Title: DA/61540/2021 - Section 8.2A Review - 1 and 3 Alfred Street and 315 West Street, Umina Beach - Demolition and Construction of Commercial Premises and Shop Top Housing

Central Coast
Local Planning Panel

24 November 2022 Local Planning Panel Meeting

Figure 5 - Proposed Site Plan

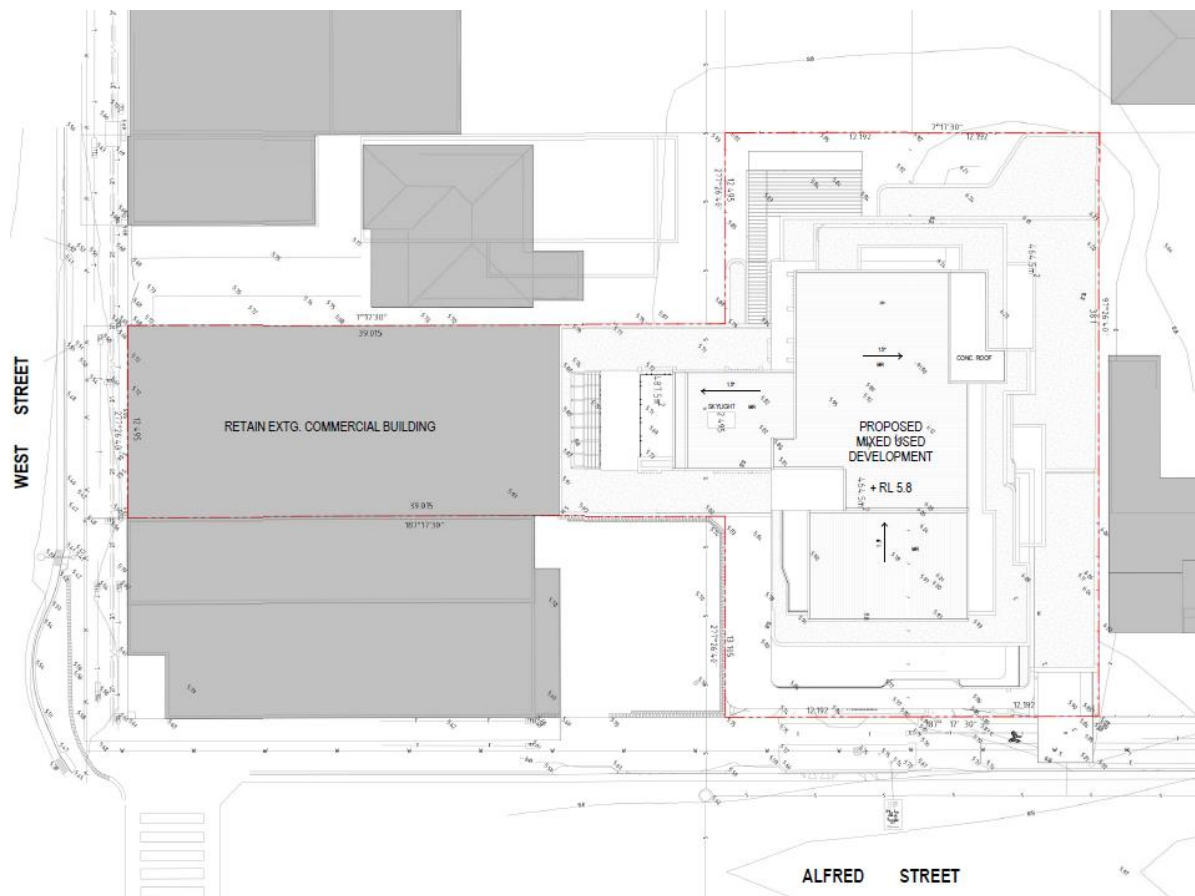
It is the use and consolidation of these particular three lots that creates the irregular T shape site and the 'pinch points' where there remain significant non-compliances with the setback

controls. The retention of the older style single storey commercial building on 315 West Street and the shifting or 'borrowing' of the FSR onto the rear of the site results in a built form of a bulk and scale larger than what the controls envision for the rear of the site. Rather than creating a larger more rational lot suitable for a larger redevelopment, the consolidation creates an awkward T-shaped site, the impacts of which are exacerbated as the development concentrates the bulk and scale on only two out of the three lots.

The setbacks do not comply with the ADG and GDCP requirements and do create 'pinch points' at the interface with the neighbouring properties on West Street. This will, to a degree, impact the development potential and/or amenity outcomes of 323-333 and 311-313 (corner block) West Street.
